HEAVY VEHICLE LOCAL ROAD REPORT

Sydney Metro West – Western Tunnelling Package
Clyde/ Rosehill

Document Title	Clyde/ Rosehill Heavy Vehicle Local Road Report
Project Name	Sydney Metro West – Western Tunnelling Package
Client	Sydney Metro
Document Reference No.	SMWSTWTP-GLO-CLJ-HS-RPT-000001-D.01
Revision Date	7 June 2022

REVIEW COMMENTS SHEET

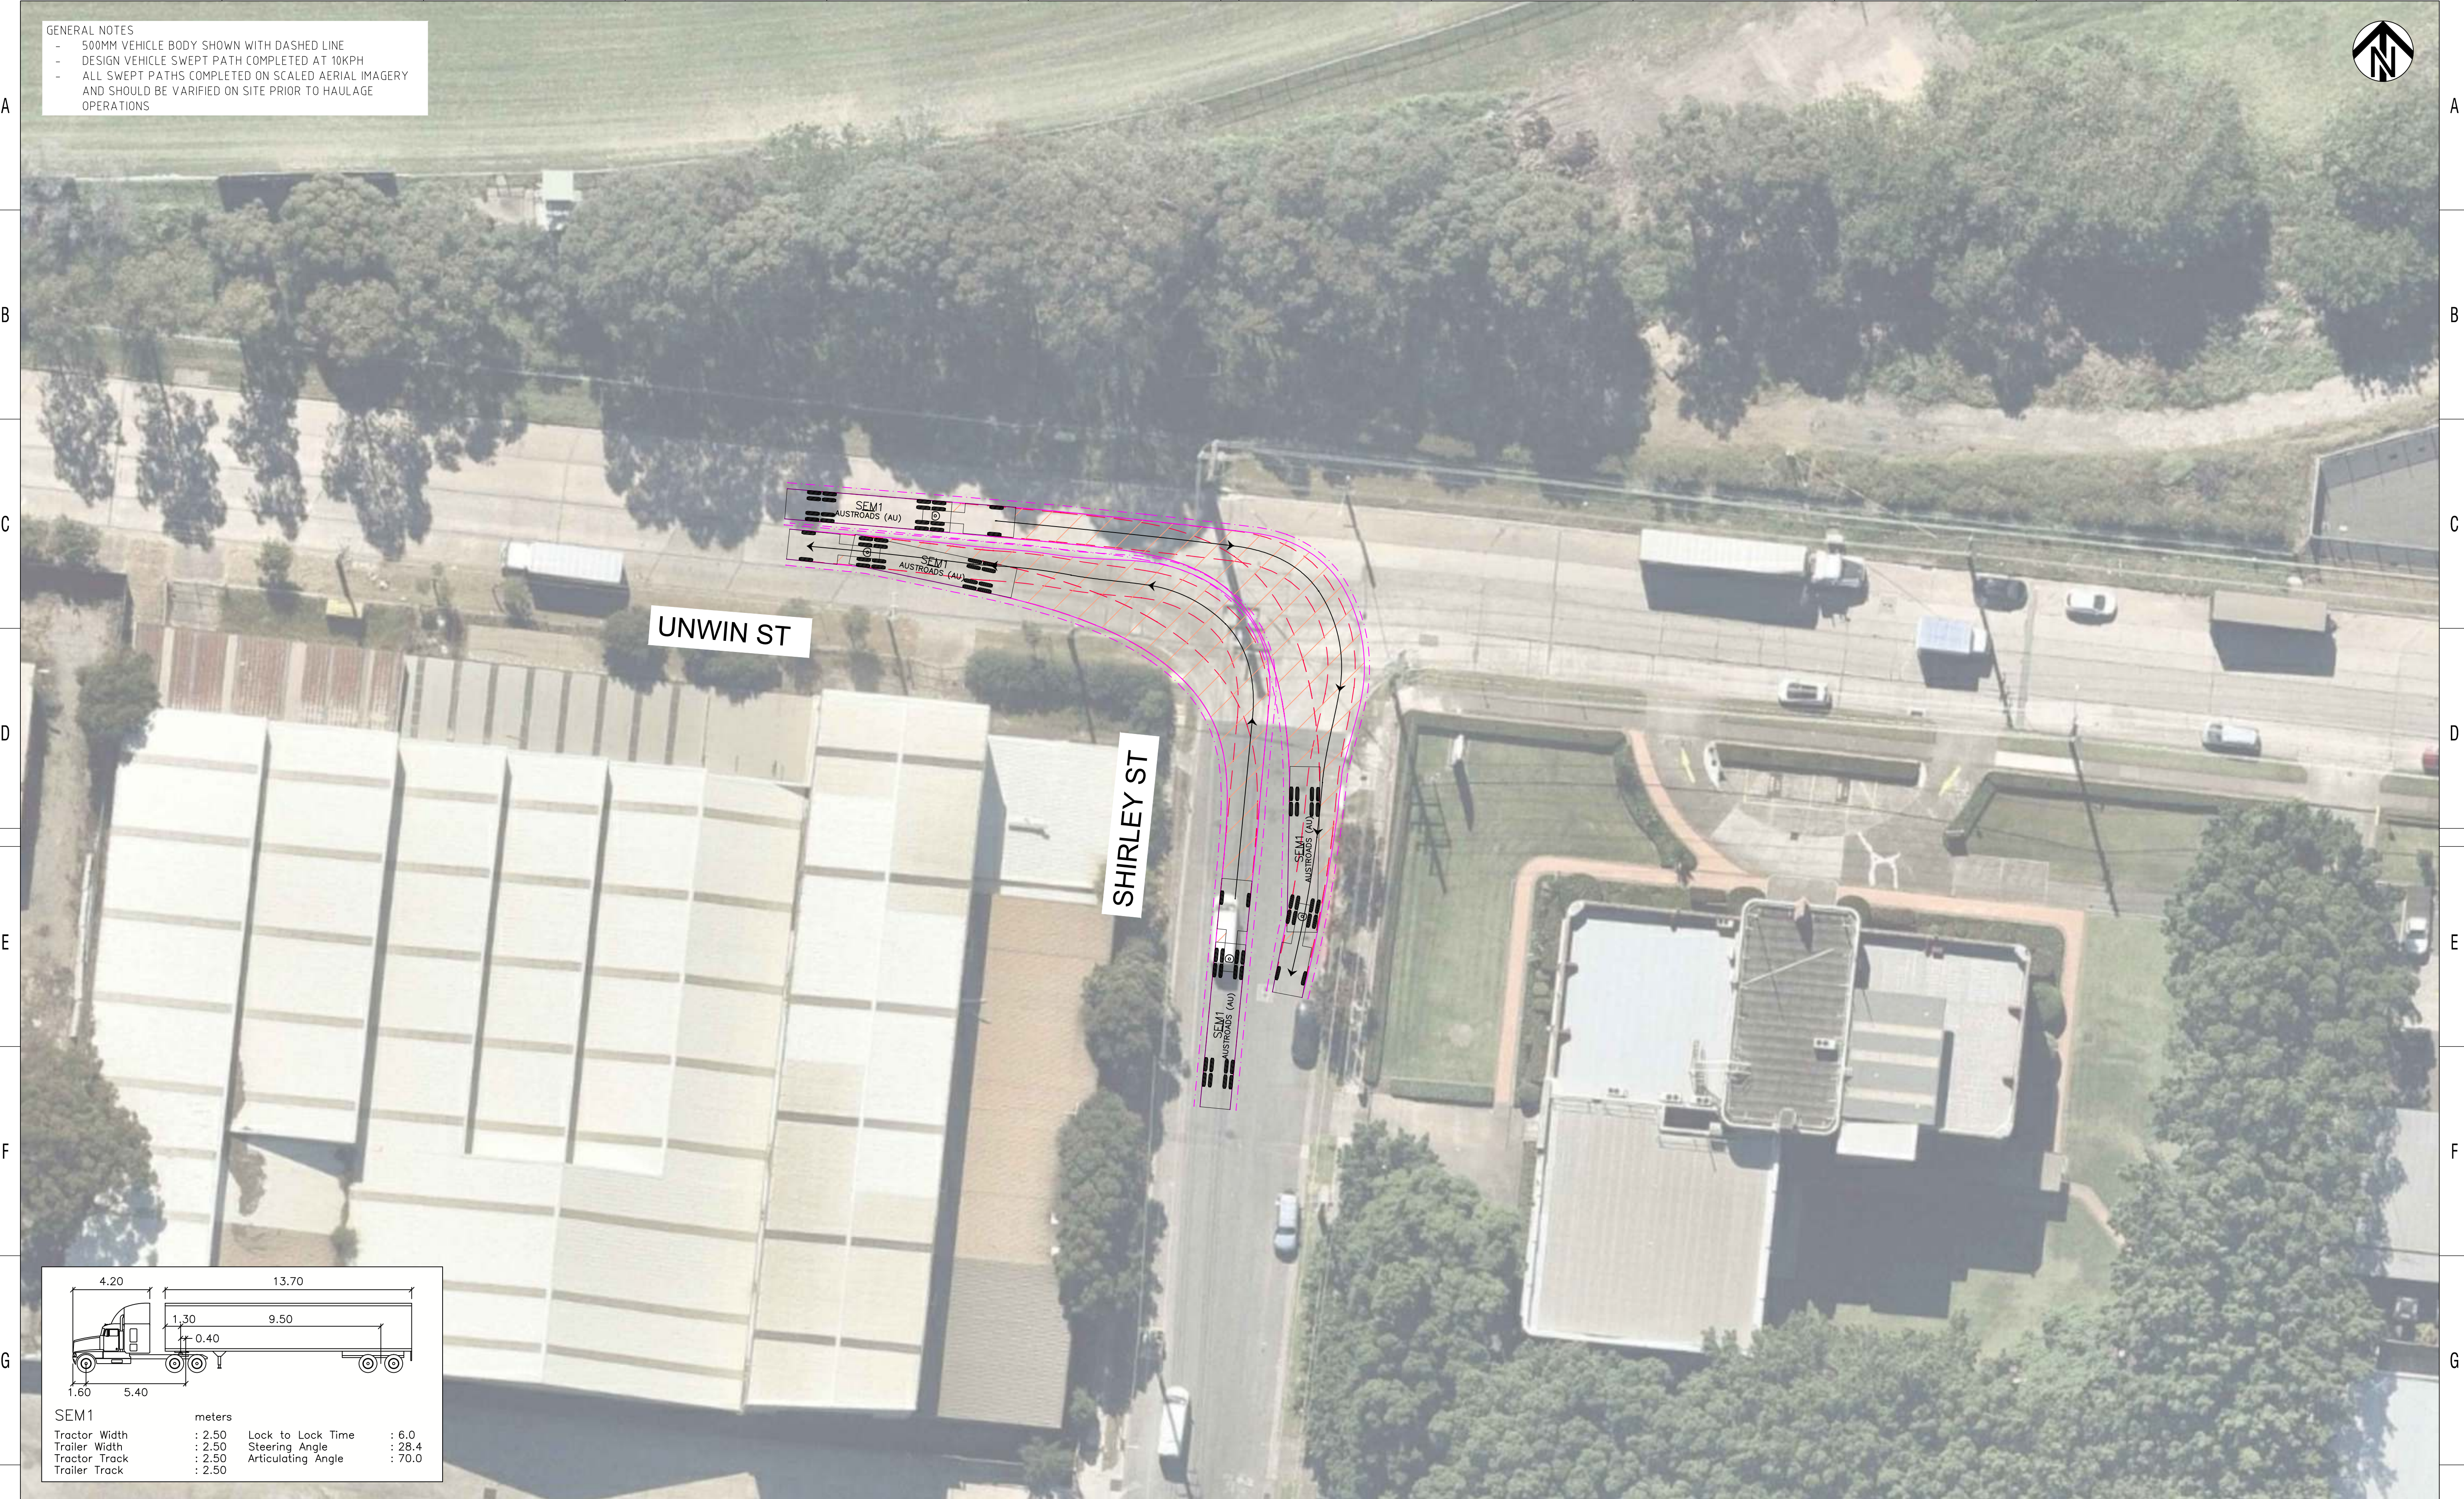
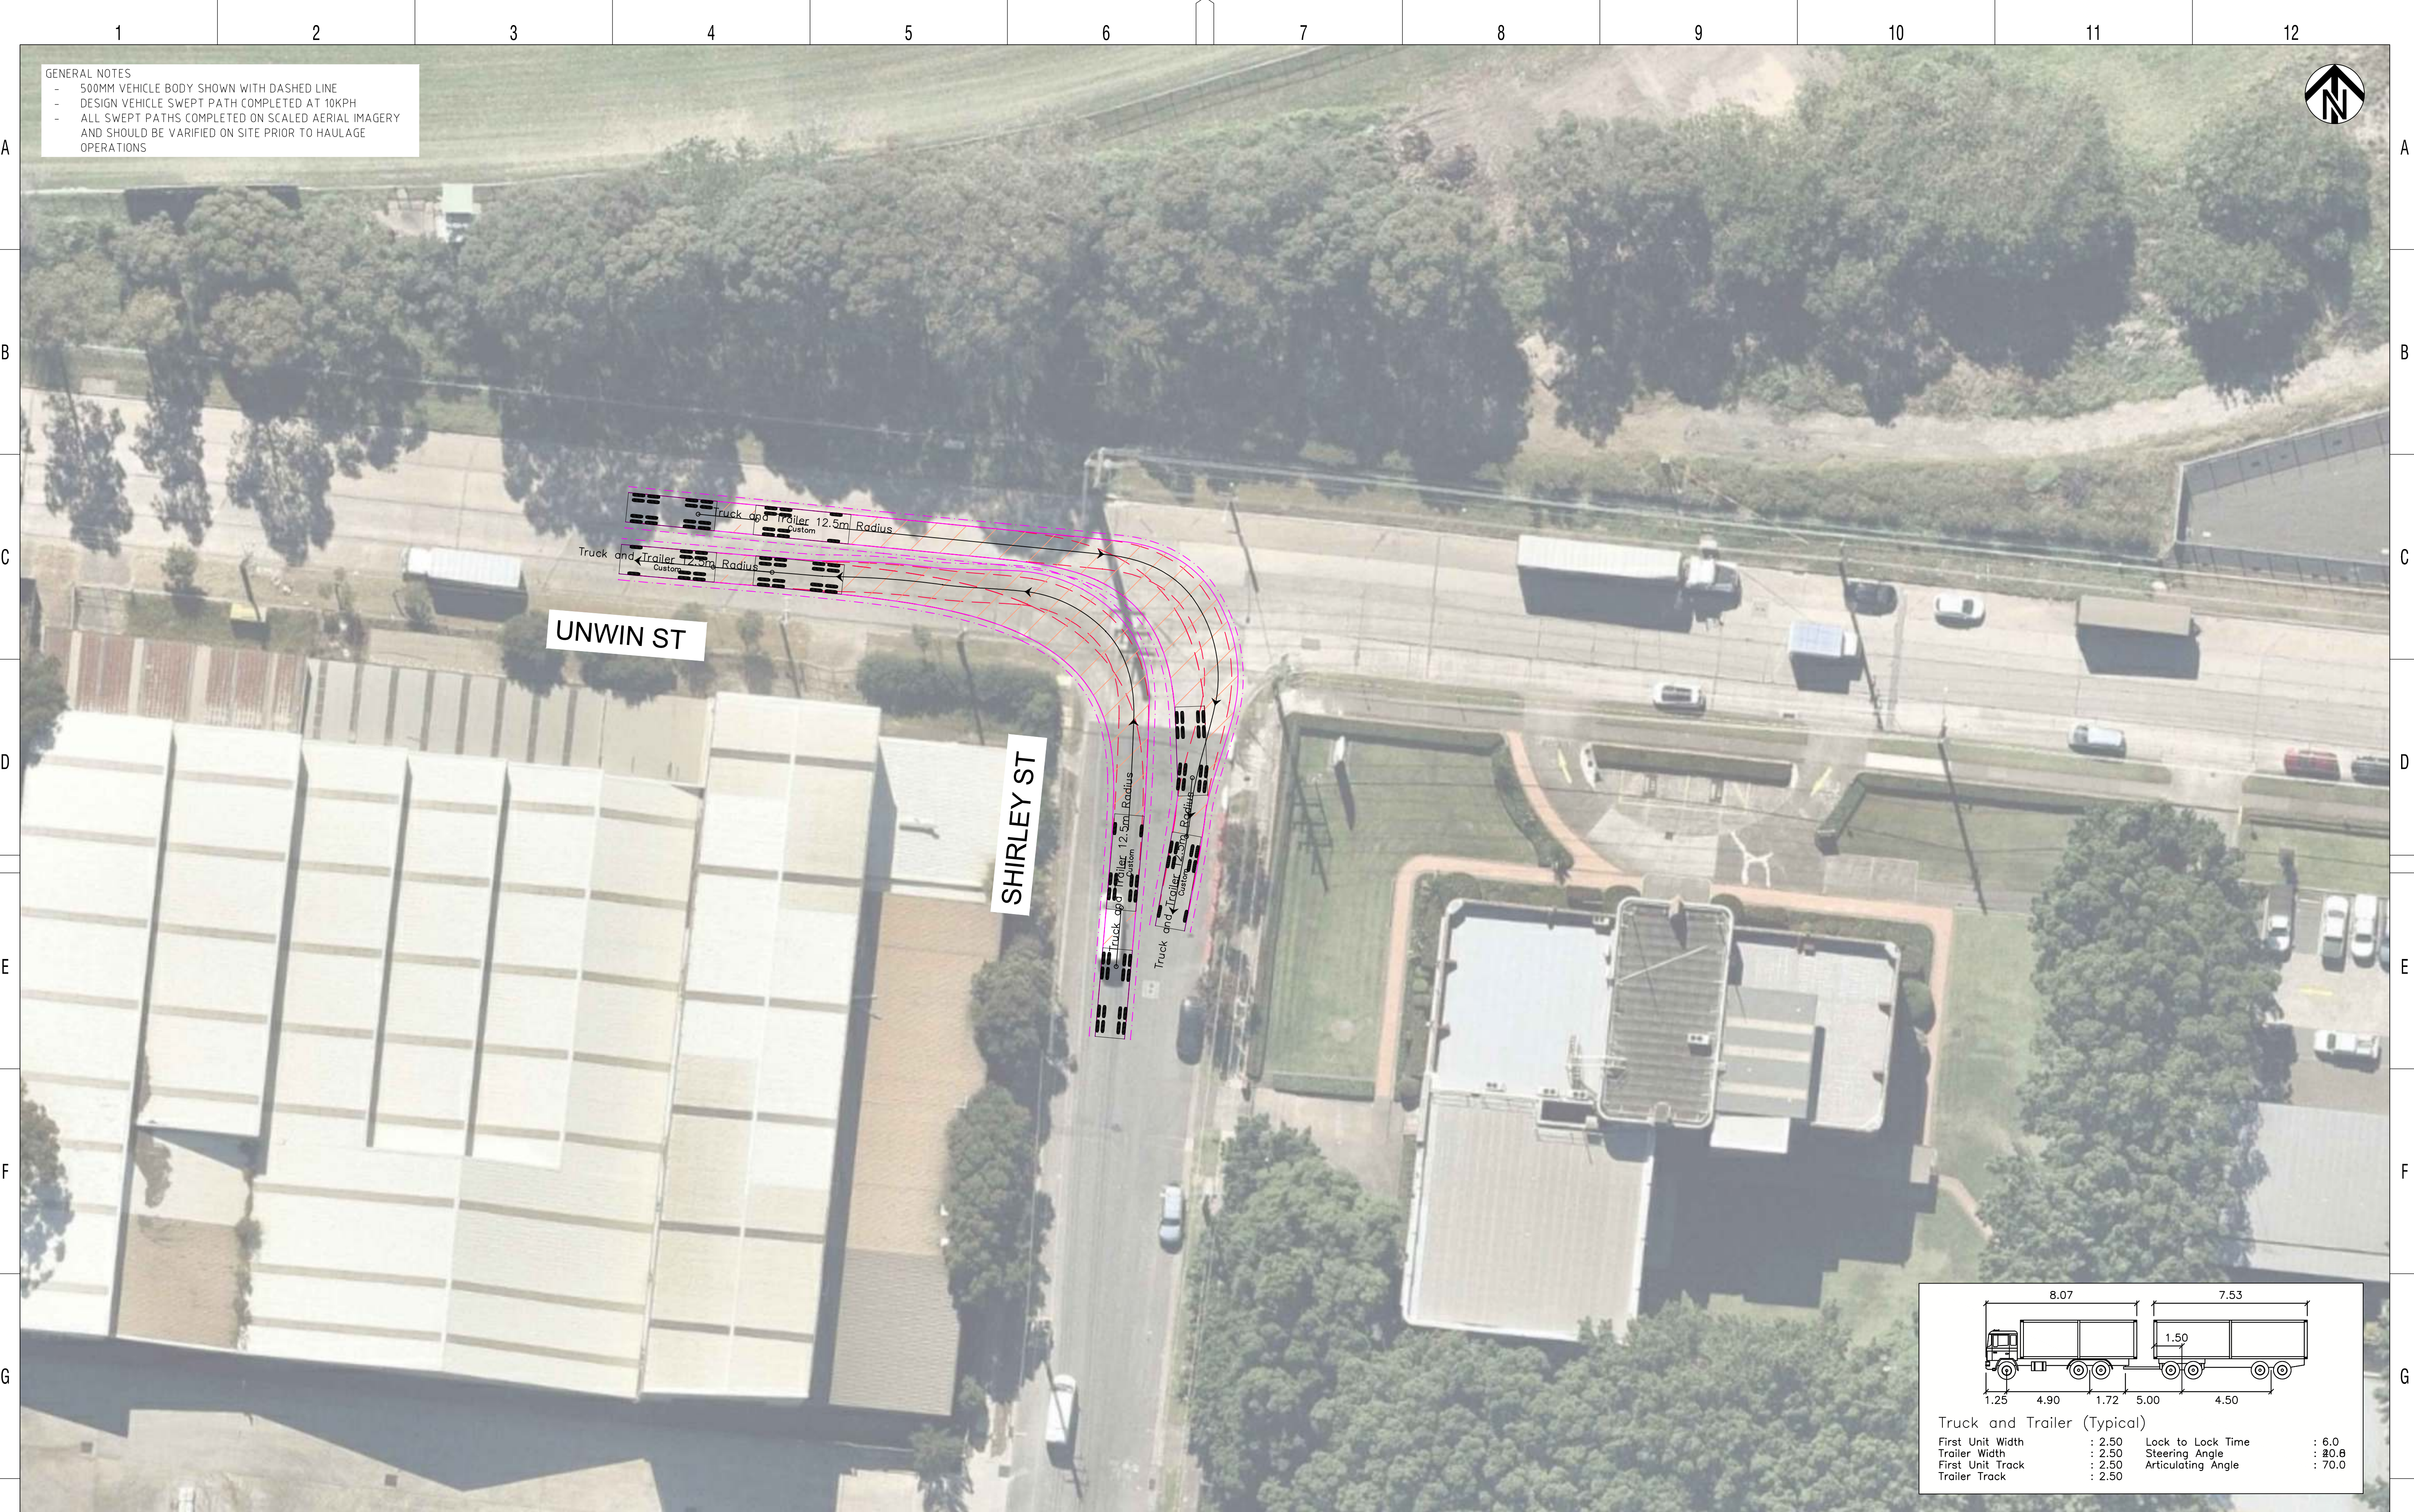
The swept path analysis supplied indicates that all semi-trailer and truck & dog turning movements can be adequately accommodated at all intersections that form part of the proposed heavy vehicle route other than at the following intersections:

- Unwin Street onto Shirley Street;
- Martha Street onto Wentworth Street.

Semi-trailer movements at the above two intersections will not be permitted and drivers will be instructed accordingly during training and induction.
